## Hyde County Schools Central Office Roof Replacement

### Addendum No. 2

March 5, 2023

HYDE COUNTY SCHOOLS CENTRAL OFFICE  
**PARTIAL RE-ROOFING PLAN**  
 O.A. PEAY CAMPUS  
 1430 MAIN STREET, SWAN QUARTER, NC 27885  
 CAHOON AND KASTEN ARCHITECTS, PC  
 BEN CAHOON, FAIA, PRINCIPAL ARCHITECT  
 118 W. WOODHILL DRIVE  
 NAGS HEAD, NC 27959  
 252-441-0271 office@obxarchitects.com

ROOF PLAN +/- 1/6" = 1'-0"

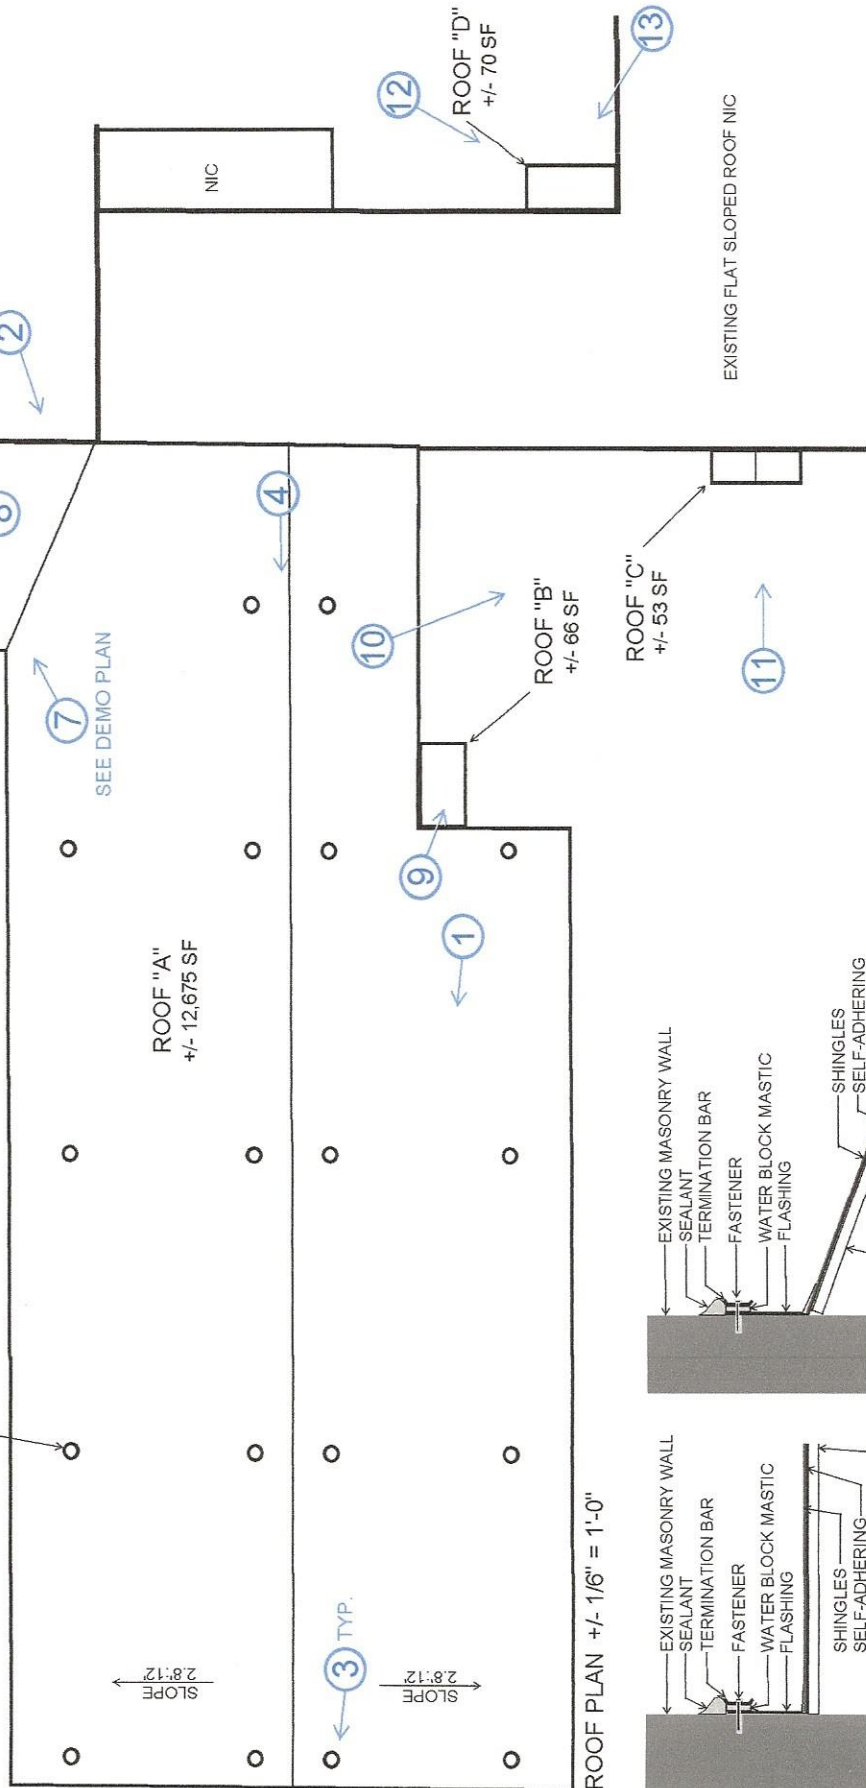
1. The attached Rev. Roof Plan indicates approximate areas for each roof.
2. Bidders are advised that there are two layers of shingles on the existing roof.
3. Bidders shall include a per-sheet (48 in. x 96 in.) x 5/8 in. price for replacing existing roof sheathing.
4. Roof B is to be a single-ply TPA membrane over cover board over the existing plywood. At wall use a termination bar detail, similar to that shown on the drawings. At the drip edge approximate the detail shown below re-using the existing gutter.

INSTALL (18) ROUND STATIC ROOF VENTS
